Subj: South Main Street Safety Improvement Project – Planning Commission Recommendation

**Re:** **State Route 91 South Safety Improvement Project (PID 106445)- Viewpoint #20-844 Engineering Response and Recommendations from Planning Commission**

### SOUTH MAIN STREET SAFETY IMPROVEMENT PROJECT

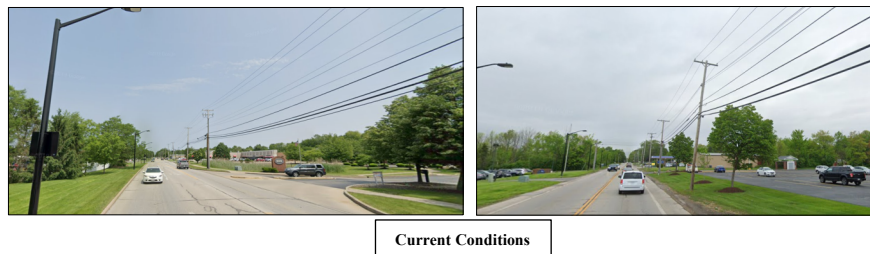
- **Recommendation:** *Further study the feasibility of incorporating street trees along the west side of the road and streetscape landscaping throughout the entire project area to create a safer and more welcoming environment for pedestrians and cyclists.*

The current project area does not have street tree plantings and the current scope of work does not include street trees. Through the Planning Commission review, the City Arborist was consulted on the feasibility of adding street trees through the length of the project area and determined there is an opportunity for tree plantings on the west side of the road. The Arborist recommended planting Honey Locust trees due to their versatility.

The Planning Commission was supportive of planting street trees along the west side of the street and questioned if additional landscaping could be provided in areas where trees are not feasible.

Response: Street trees could be added to the current plan set with minimal effort, cost, and no delay to the project. However, design of “streetscape landscaping” throughout the project corridor would require an additional design fee from a landscape architect for the design, additional cost of the streetscape landscaping, potential property acquisition, and would likely delay the final design acceptance of the project. It should also be noted that the City Arborist reviewed the project corridor for the addition of street trees and only recommended they be added to the west side of the road due to conflicts with the overhead power lines on the east side of the road.

**Recommendation: Only add street trees along the west side of SR 91 to the current project and consider potential “streetscape landscaping” for a future project.**

CONCEPTUAL PLAN VIEW  
(3) 11' LANES WITH 5' BICYCLE LANES

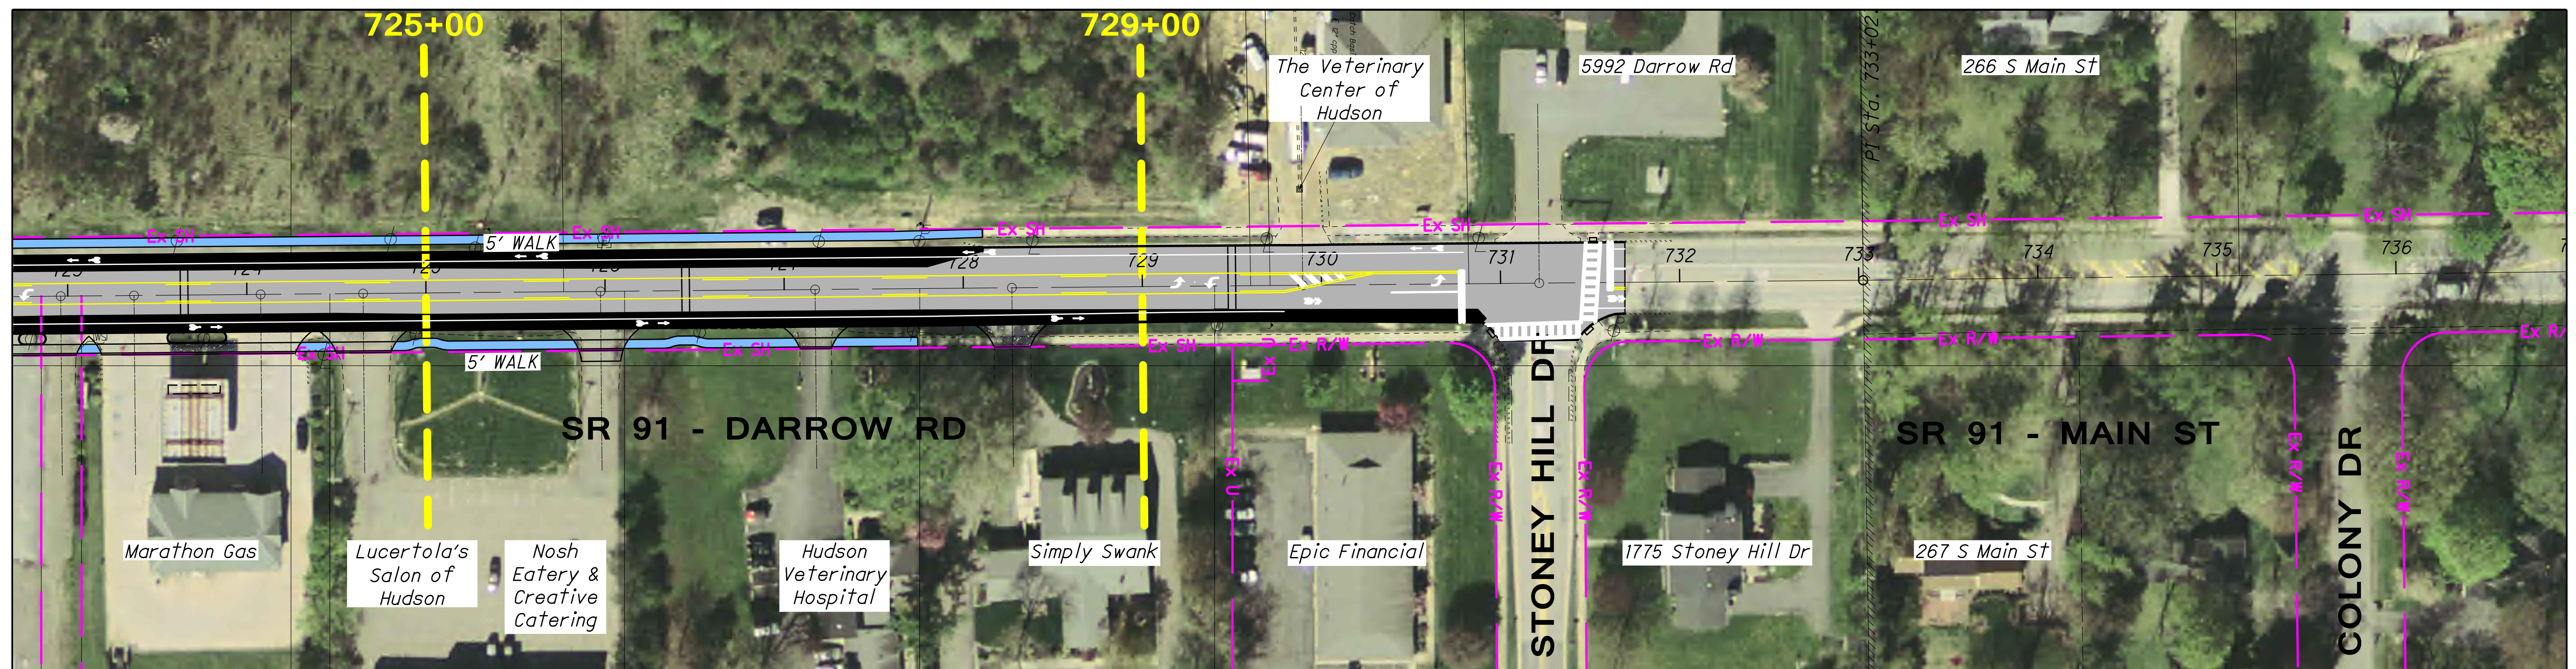
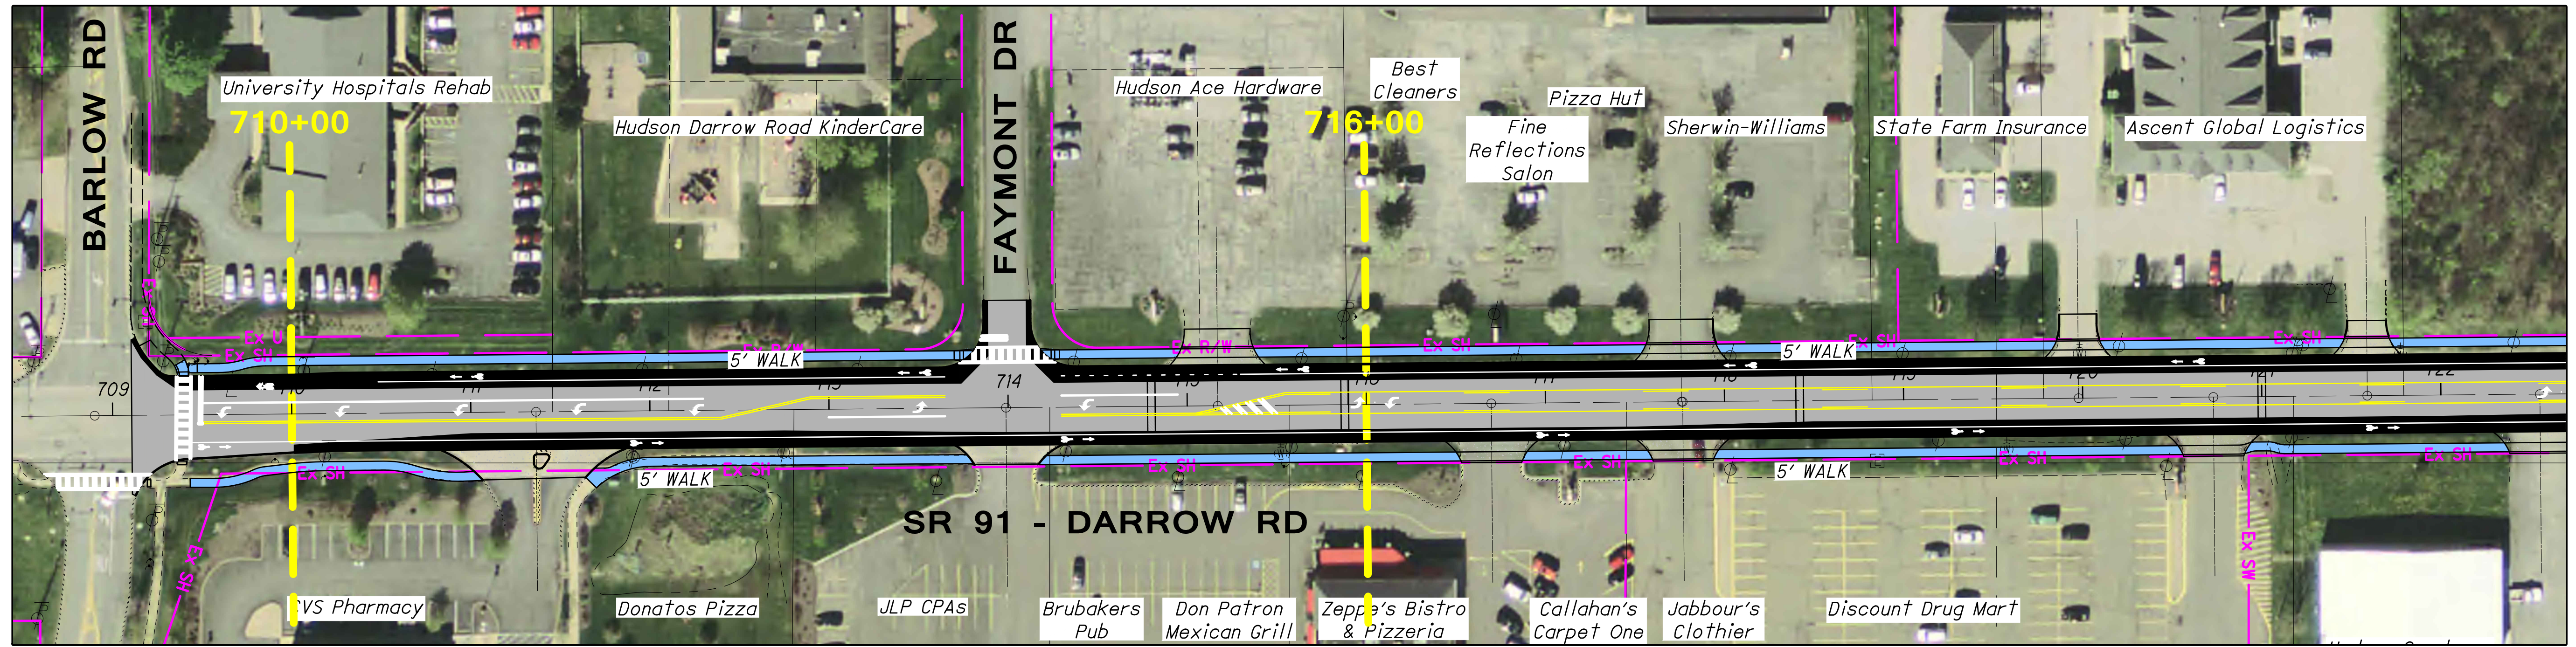
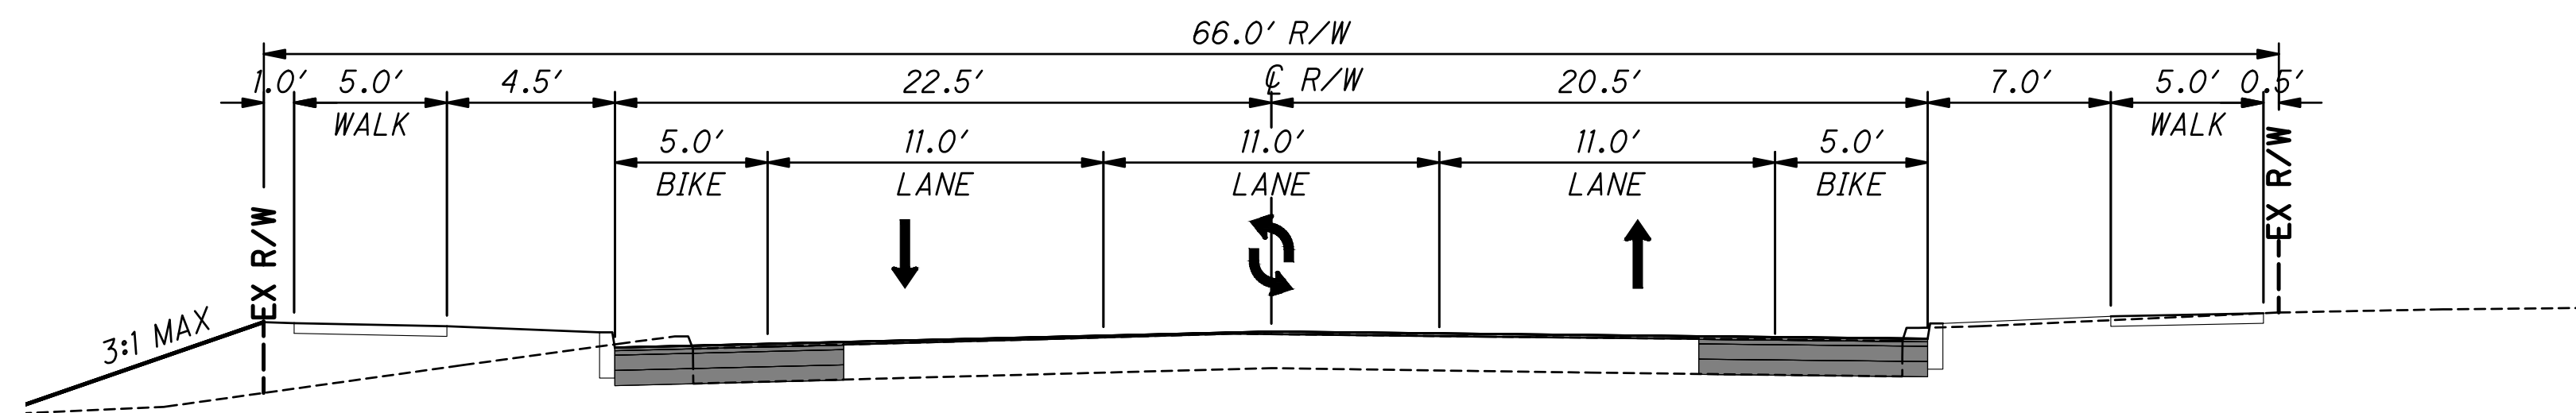
*1. Study the feasibility of reducing the width and number of existing curb cuts south of Stoney Hill Drive to improve on potential conflict points for pedestrians and cyclists.*

*2. Further study the feasibility of incorporating street trees along the west side of the road and streetscape landscaping throughout the entire project area to create a safer and more welcoming environment for pedestrians and cyclists.*

*3. Study the feasibility of moving overhead utilities underground.*

*4. To the extent feasible, minimize negative impacts on the occupants and users of the SR 91 Corridor, including the use of night work, signage, or like practices.*

**Recommendation: Continue to finalize the design of the plans to reduce the width of some driveway aprons, but do not forcibly eliminate any driveways. Future driveway elimination may be considered in a separate project if a property owner is agreeable to the removal.**

**Recommendation: Continue with the final design and construction of the ODOT funded Safety Improvement Project without moving overhead utilities underground.**

**Recommendation: Continue to design the project to minimize negative impacts to the occupants and users of the corridor and remain compliant with ODOT design requirements.**
